Todd Groundwater, Antelope Valley Watermaster Engineer

September 2025

Figure 4
Magnolia Parcel and
Total Land Subsidence
(2015 - 2024)

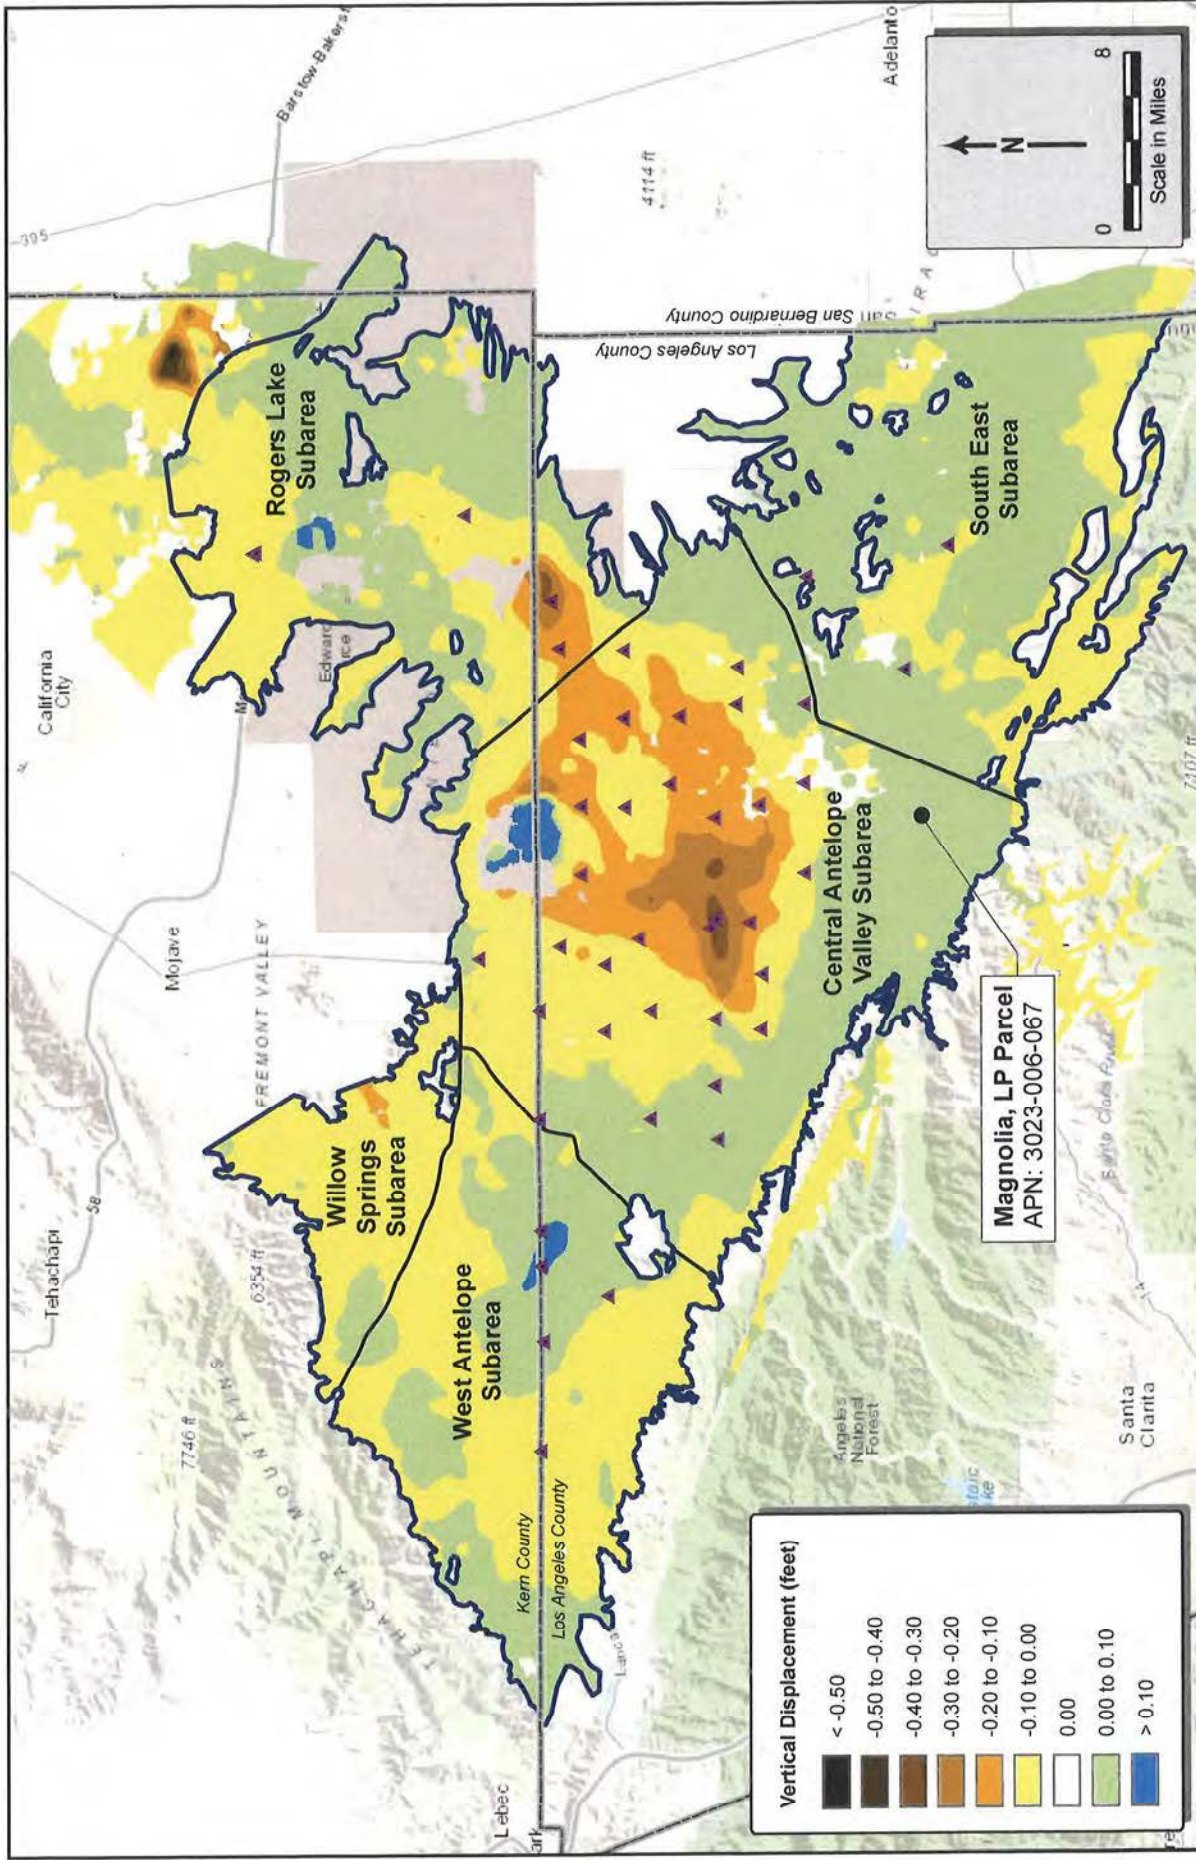
This well is not in an area where subsidence has been observed. **Figure 4** shows the location of the parcel, APN #3023-006-067, relative to vertical displacement between 2015 to 2025. The parcel lies in an area where less than 0.1 feet (1.2 inches) of cumulative subsidence has occurred since 2015.
